## Change Order

Williamson County  
Animal Shelter Expansion  
1855 SE Inner Loop  
Georgetown, TX 78626

Change Order Number: 006

Change Order No. 6 includes the below listed Vaughn Change Proposals # 27-#31. For Vaughn Project No. 2491-01.

1 KENNEL - DEMOLITION - HVAC PLAN  
1/8" = 1'-0"

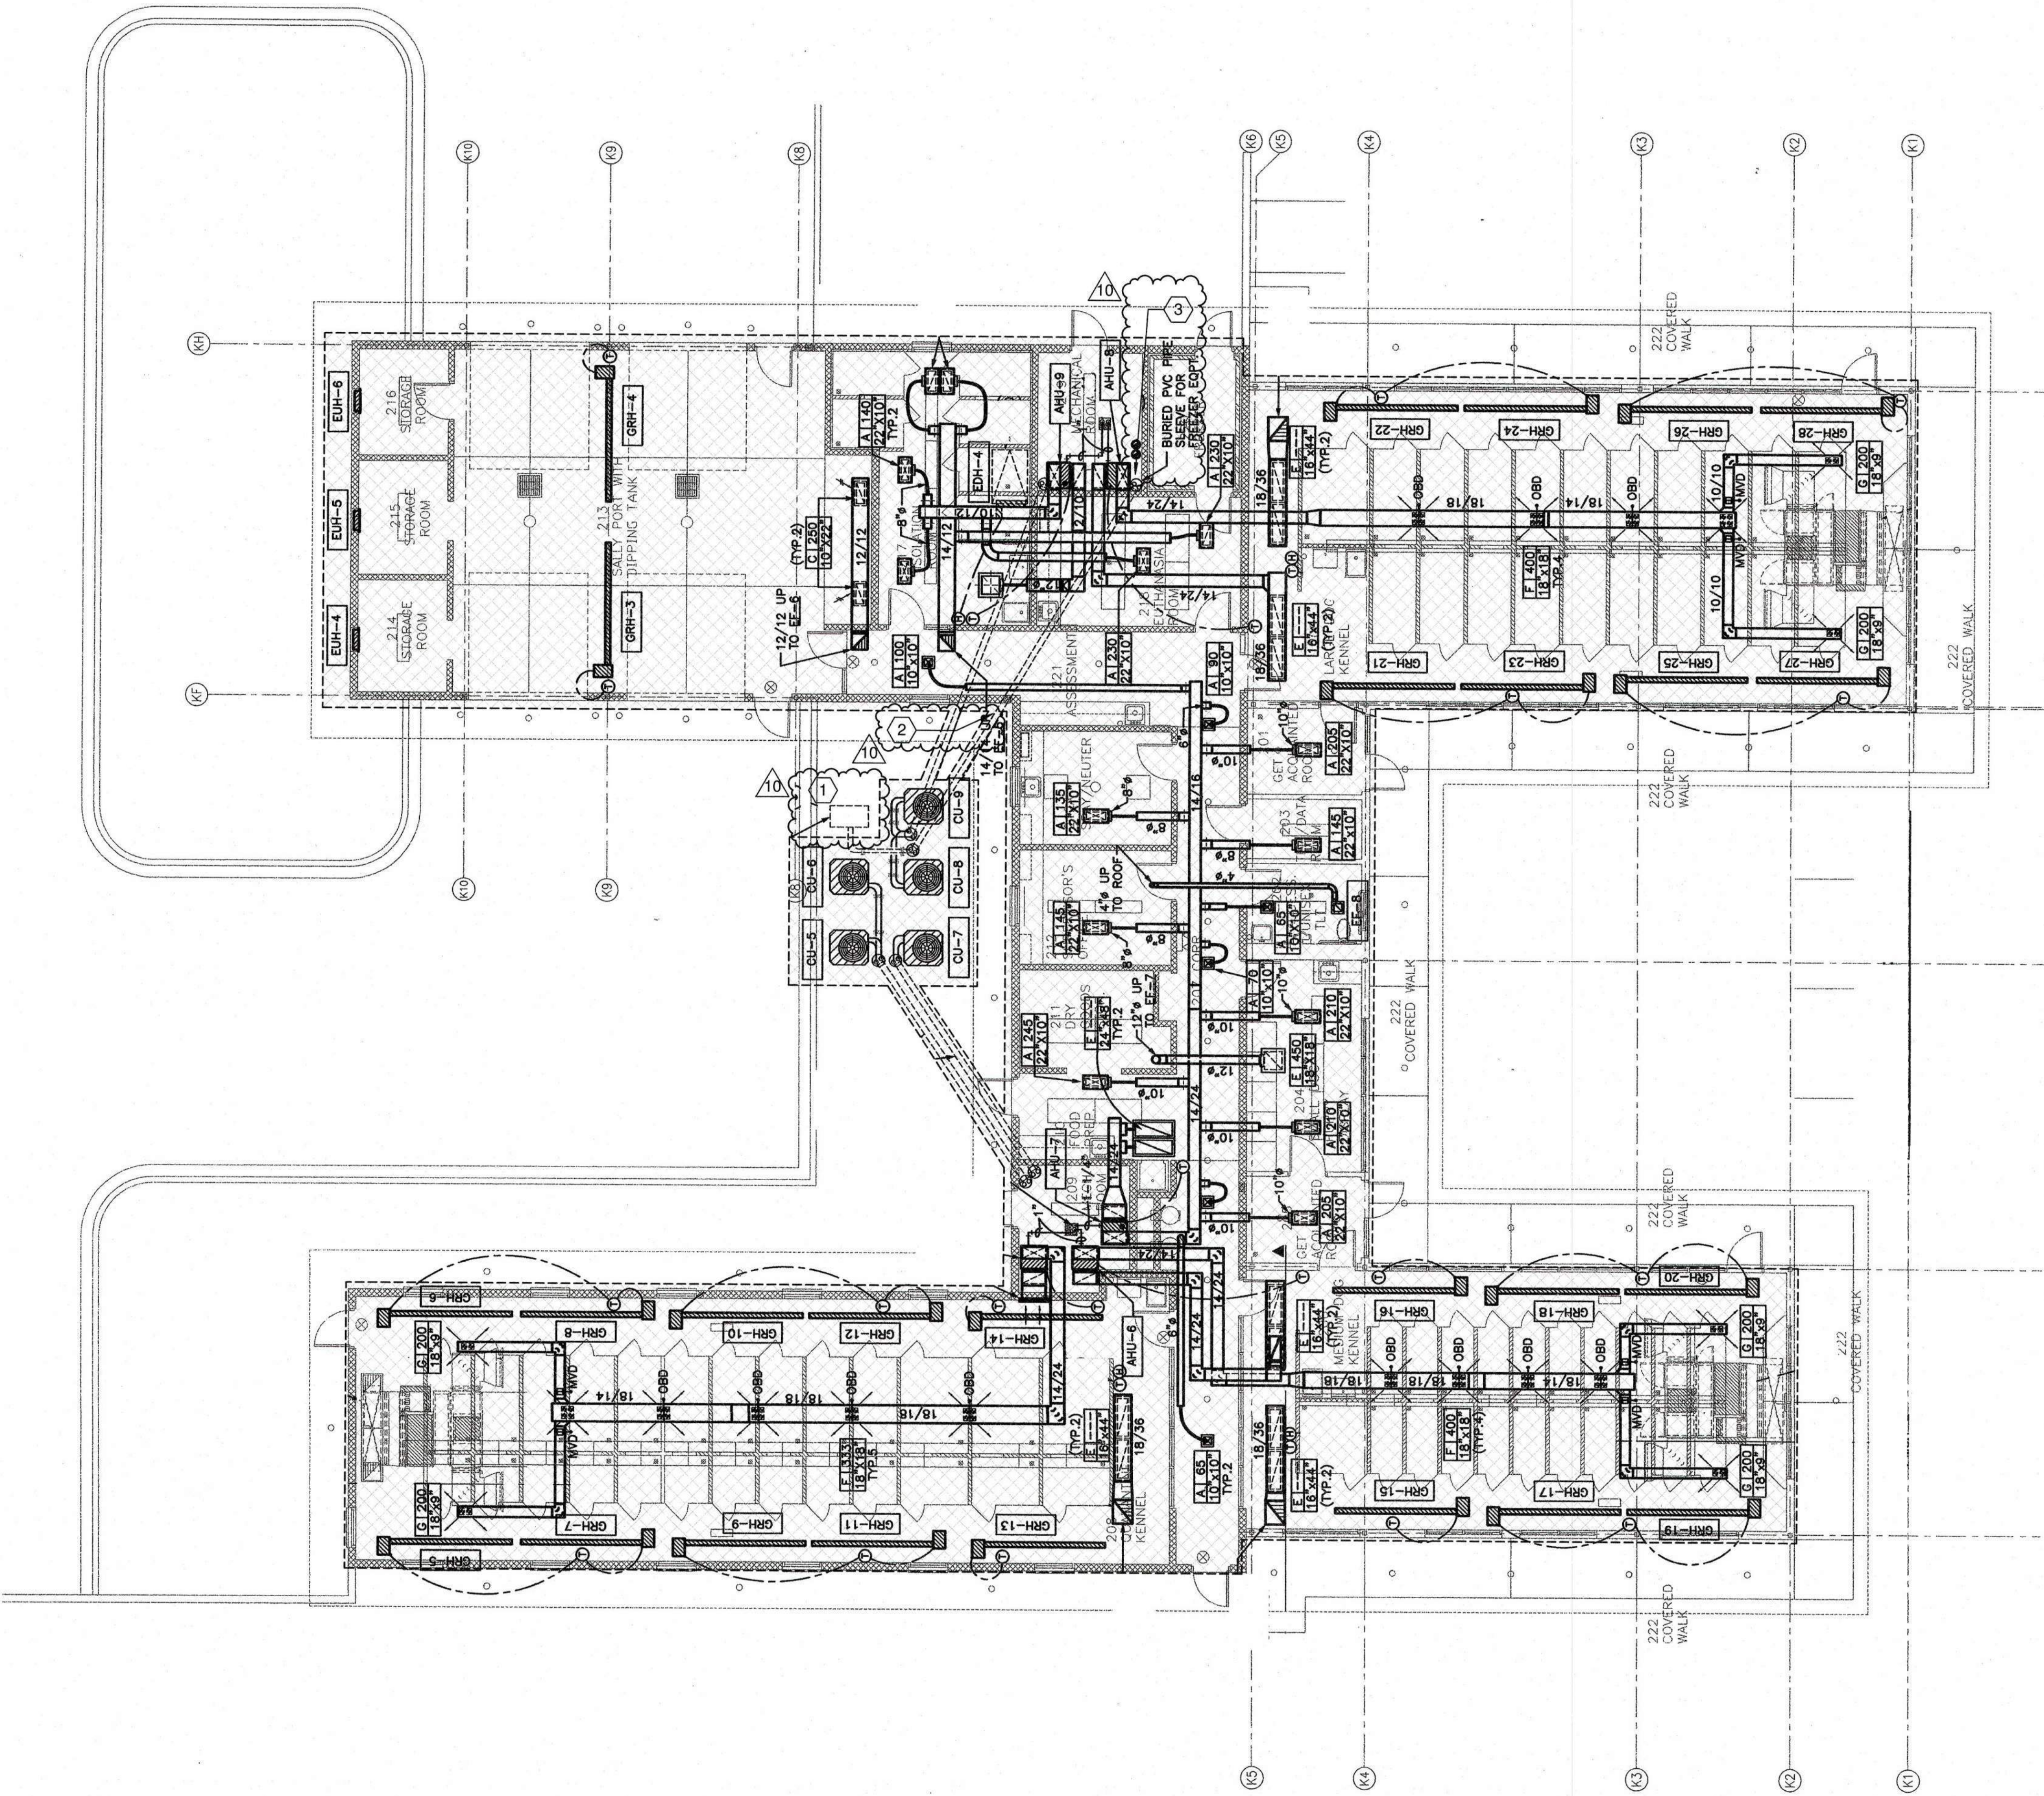
**Re:** Existing Freezer Condensing Unit Relocation

The existing freezer condensing unit at the Kennel Building will need to be relocated due to the demolition of the existing pad. Please see the attached showing the proposed new location and let us know if this is acceptable and what requirements will be needed for the relocation.

- RELOCATE EXISTING FREEZER CONDENSING UNIT TO LOCATION MARKED ON SHEET M.2-3.01. DEMO PVC PIPING TO LOCATION INDICATED BY KEYED NOTE 2 AND CAP THE PVC PIPING THERE. ABANDON PVC PIPING UNDER THE BUILDING SLAB. DEMO EXISTING REFRIGERANT PIPING TO LOCATION INDICATED BY KEYED NOTE 3. REUSE EXISTING CONDENSING UNIT PAD. IF PAD CANNOT BE REUSED PROVIDE AN IDENTICAL PAD FOR THE NEW LOCATION. PAD SHOULD
- CAP EXISTING PVC PIPING HERE. ABANDON PVC PIPING UNDER THE BUILDING SLAB.
- REFRIGERANT PIPING THRU FLOOR.

1 KENNEL - POWER PLAN - RENOVATION  
1/8" = 1'-0"

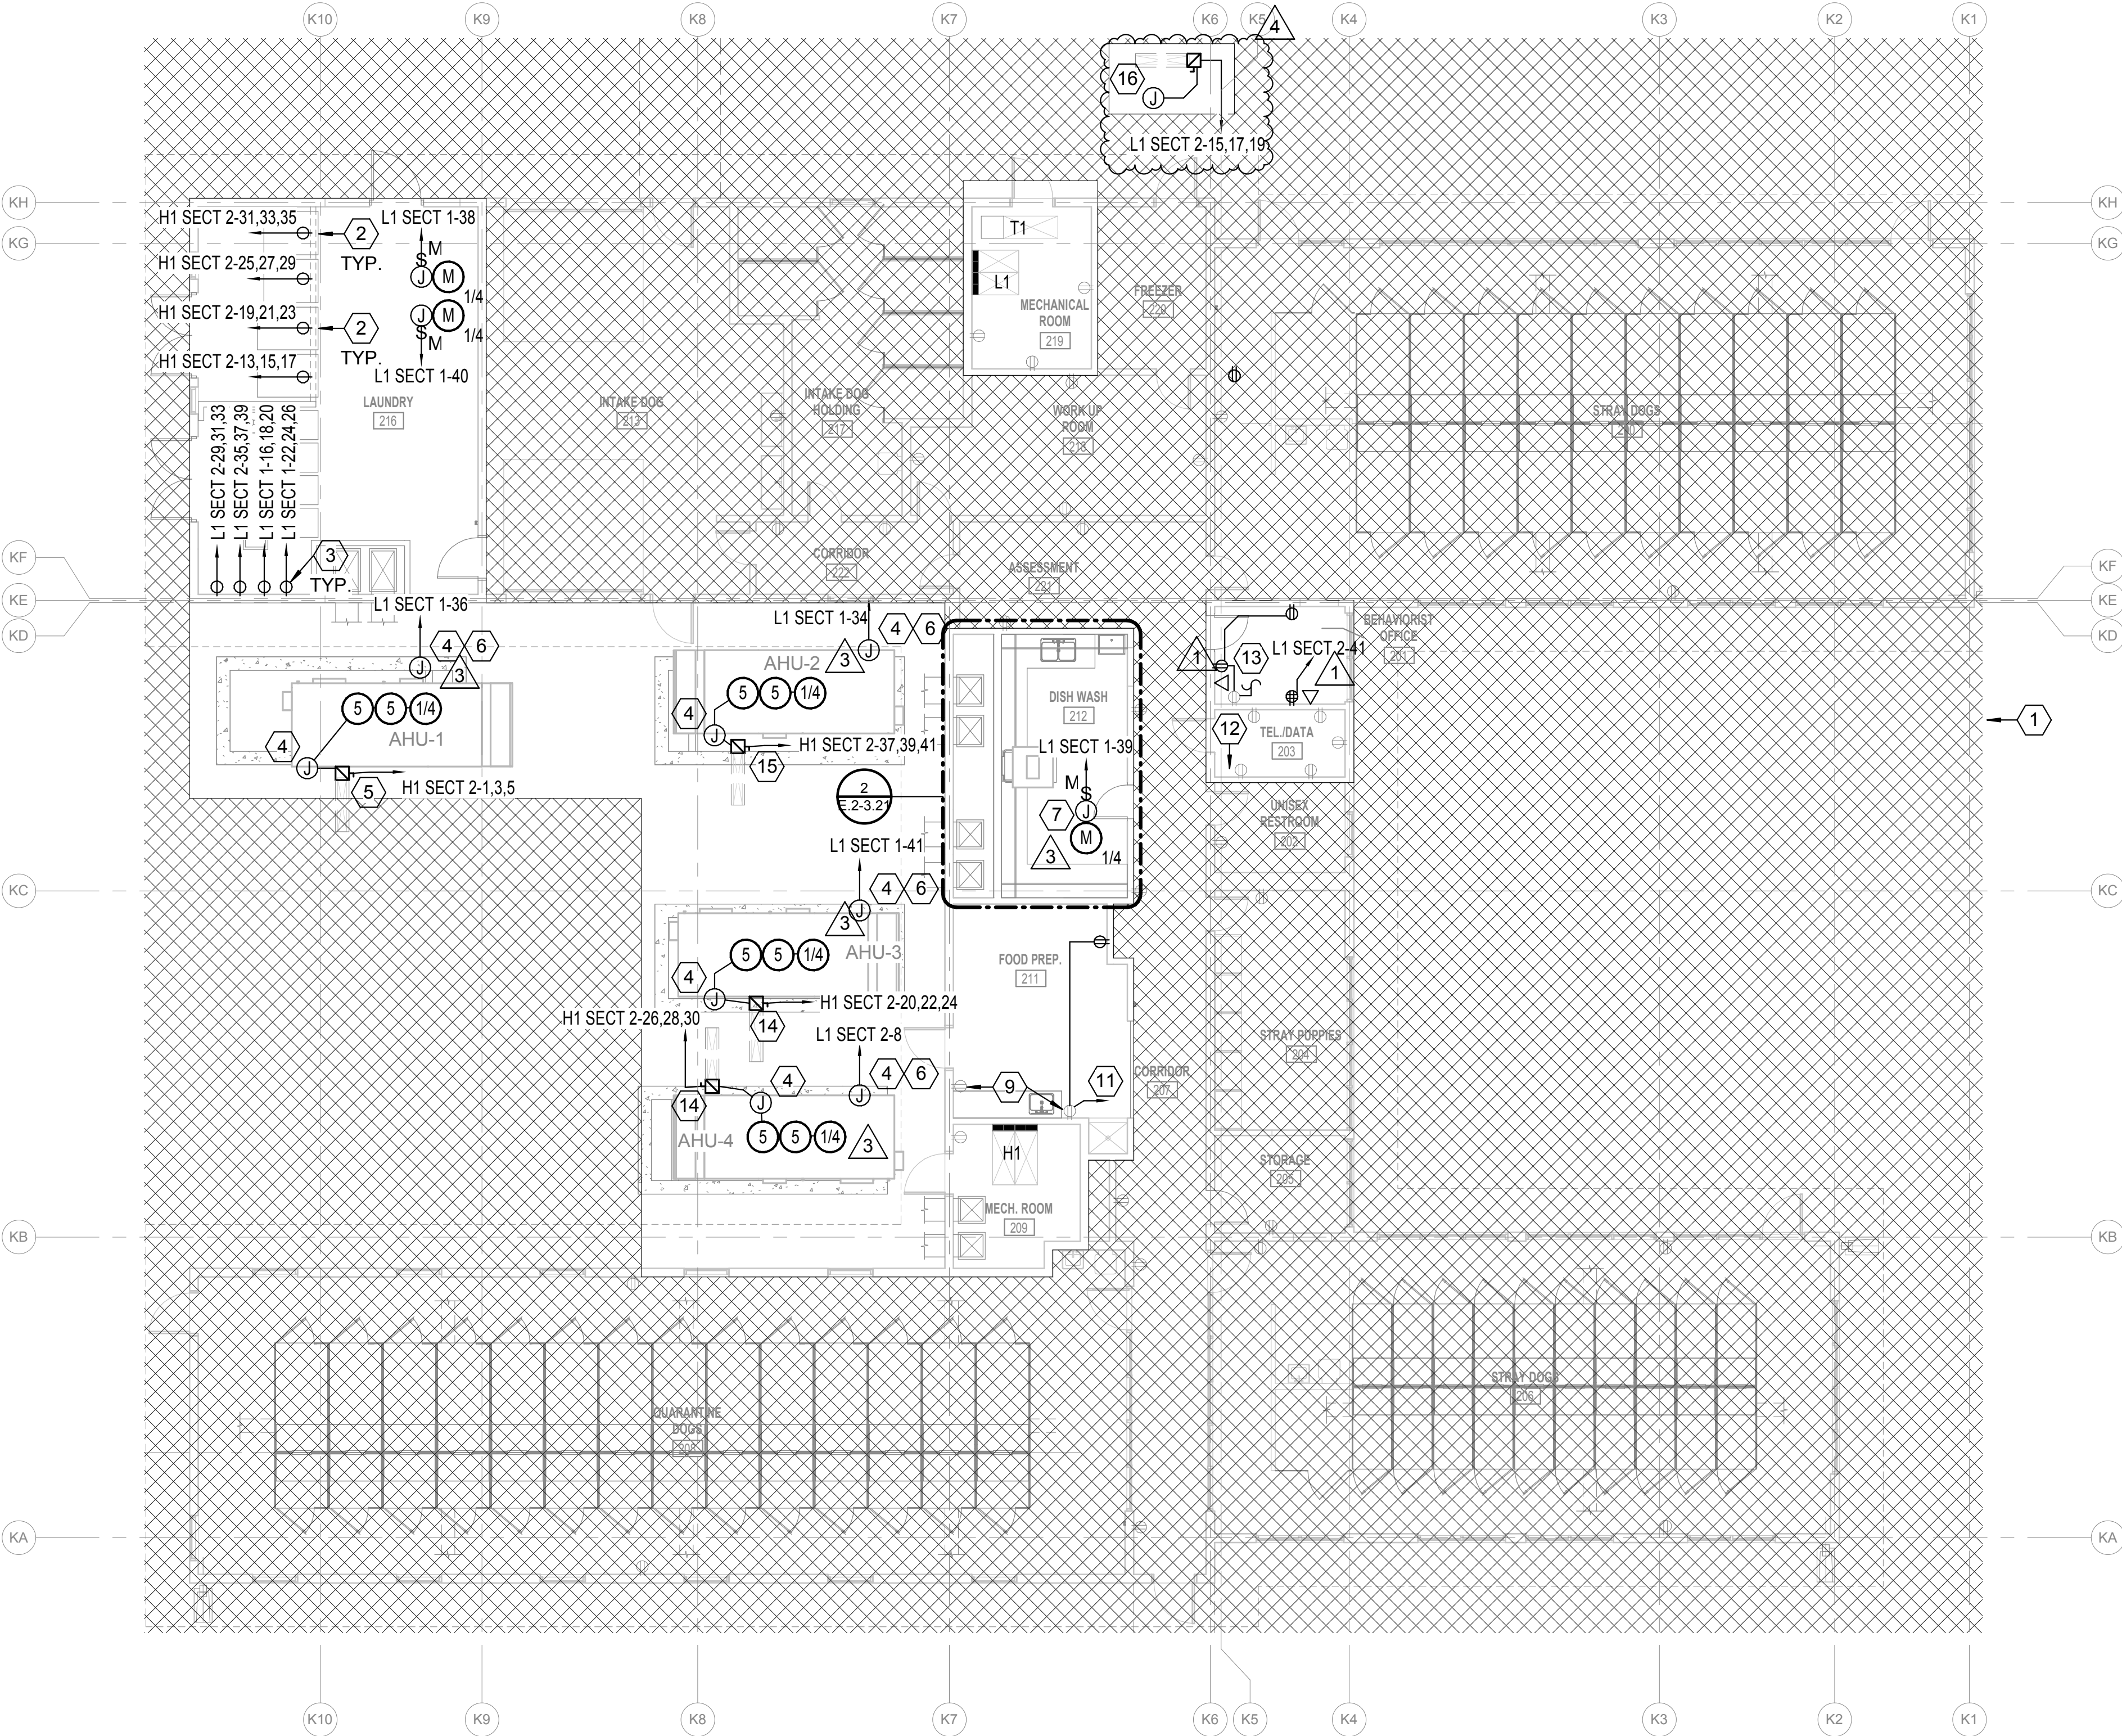
- 11 CONNECT NEW RECEPTACLES TO EXISTING CIRCUIT SERVING FOOD PREP 211.
- 12 EXTEND EXISTING CONDUIT FROM KENNEL TELECOM ROOM TO NEW ADOPTIONS TELECOM ROOM.
- 13 CONNECT NEW RECEPTACLES TO EXISTING CIRCUIT SERVING ROOM 201.
- 14 PROVIDE NEMA 3R, 60A/3P/600V RATED DISCONNECT FUSED AT 40A. UNISTRUT MOUNT DISCONNECT TO EQUIPMENT PAD. COORDINATE LOCATION WITH DIV 23.
- 15 PROVIDE NEMA 3R, 100A/3P/600V RATED DISCONNECT FUSED AT 70A. UNISTRUT MOUNT DISCONNECT TO EQUIPMENT PAD. COORDINATE LOCATION WITH DIV 23.
- 16 RELOCATED FREEZER CU. RUN CONDUIT ALONG WALL PARALLEL TO THE REFRIGERANT LINE. INSTALL RELOCATED DISCONNECT. REUSE EXISTING CIRCUIT BREAKER IN PANEL L1 SECT 2.

LIGHT POLE SPREAD FOOTING AT GRAVEL BASE

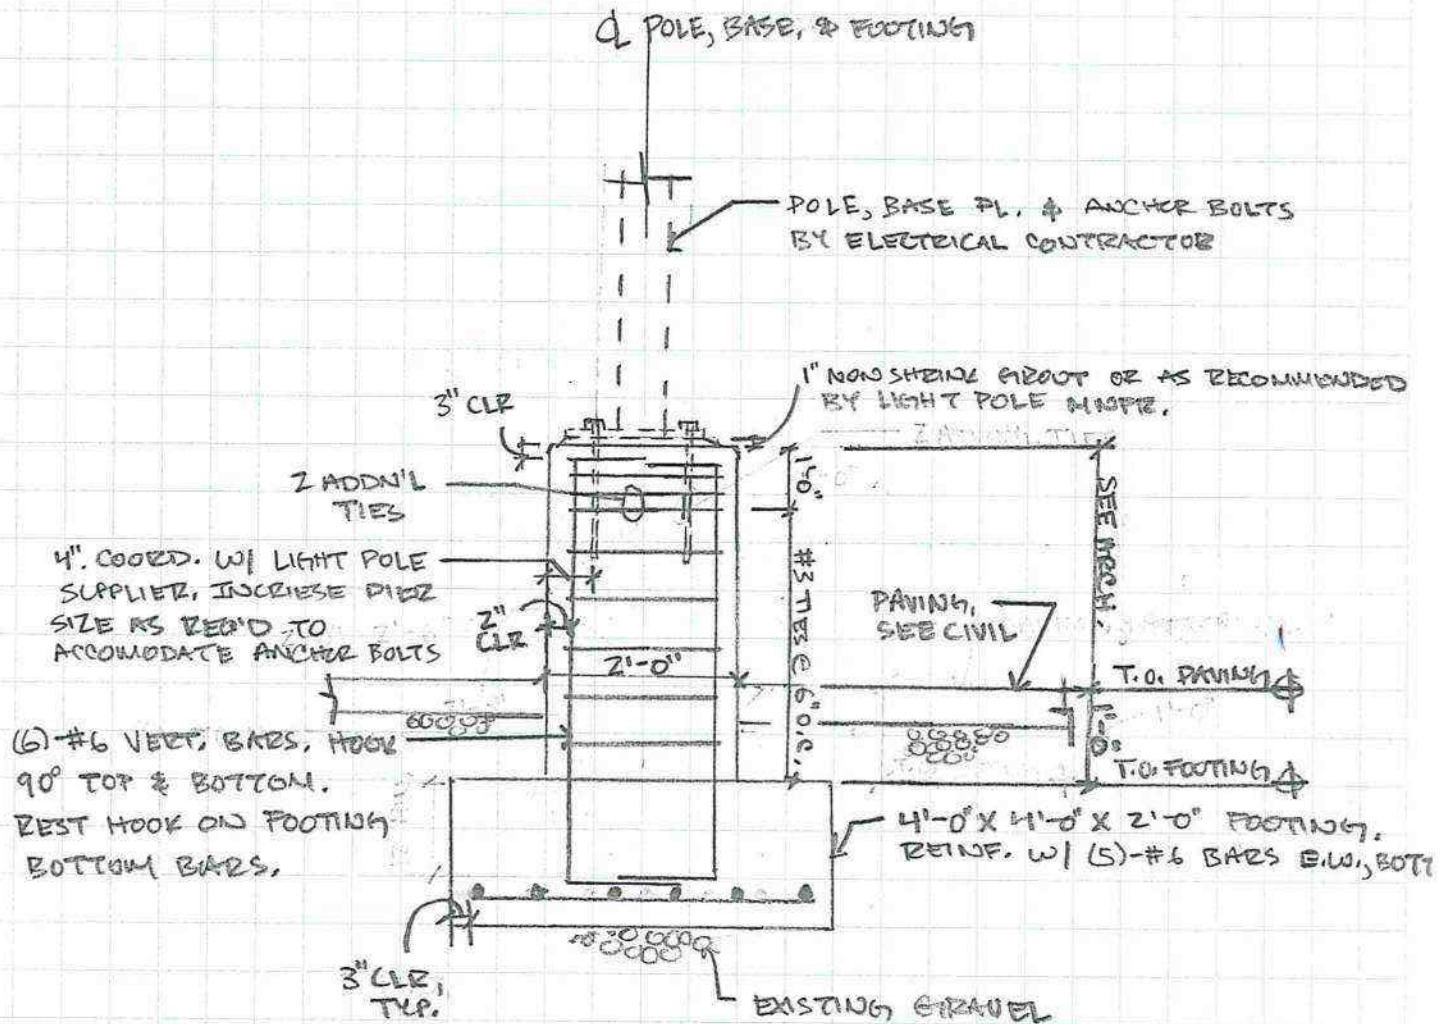
**Re:** Location of light pole pier in the gravel

The footing for the light pole located north of the New Adoption buildings parking lot next to the retaining wall is in the gravel backfill.

A spread footing may be used per the attached detail.

## TYPICAL DETAIL LIGHT POLE FOUNDATION

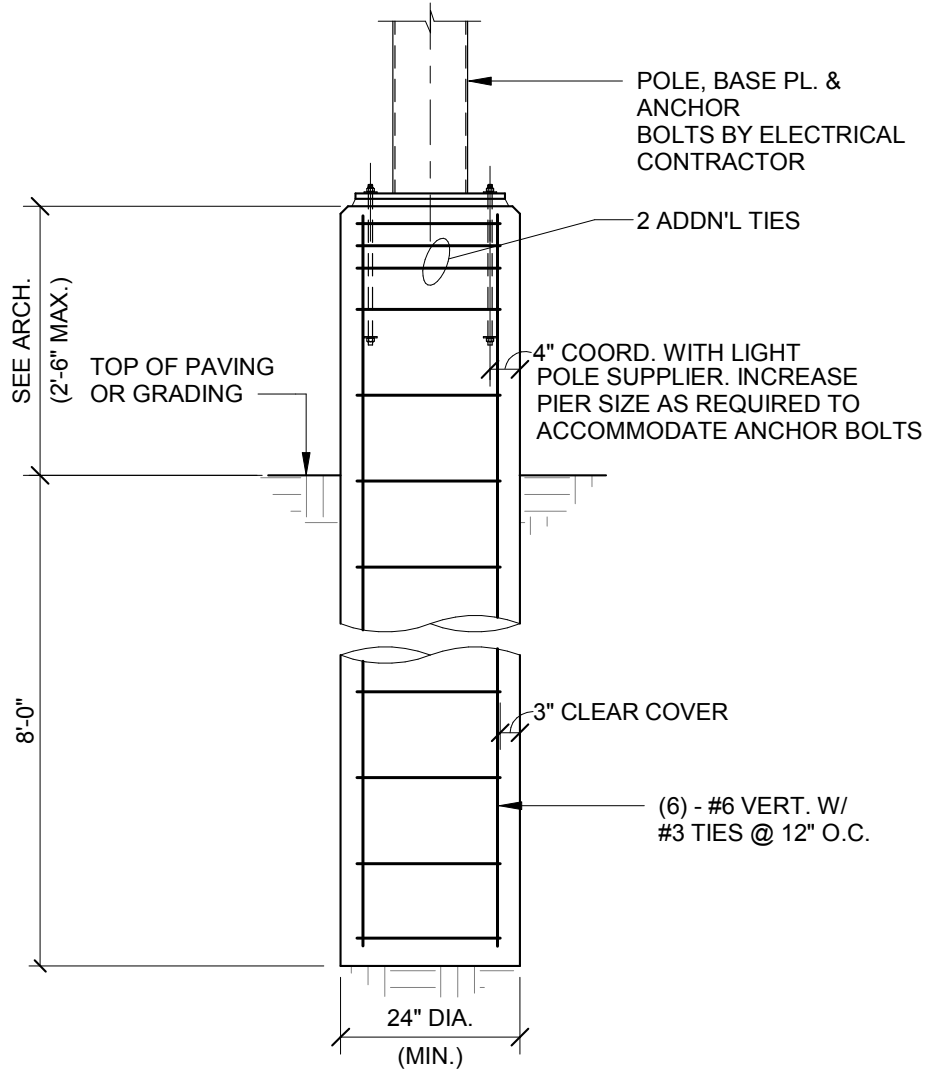
- 1) Civil page 13 shows the lighting pole detail but has no information on the reinforcement for the base
- 2) Please verify the locations of the lighting poles

See attached sketch 'SK-01' which issues new detail 11/S3.05 for the typical site light pole foundation.

1. CONCRETE SHALL HAVE A 28 DAY COMPRESSIVE STRENGTH OF 3000 PSI WITH A MAXIMUM AGGREGATE SIZE OF 3/4" AND A MAXIMUM WATER / CEMENT RATIO OF 0.54.
2. ALL REINFORCEMENT SHALL CONFORM TO ASTM A615, GR. 60.
3. ASSUMPTIONS FOR FOUNDATION DESIGN INCLUDE A 5", 25 FT. POLE W/ FIXTURES AND A MAXIMUM EQUIV. PROJECTED AREA OF 5 SQ. FT.
4. SEE ELECTRICAL DRAWINGS AND SPECIFICATIONS FOR ADDITIONAL INFORMATION AND REQUIREMENTS.
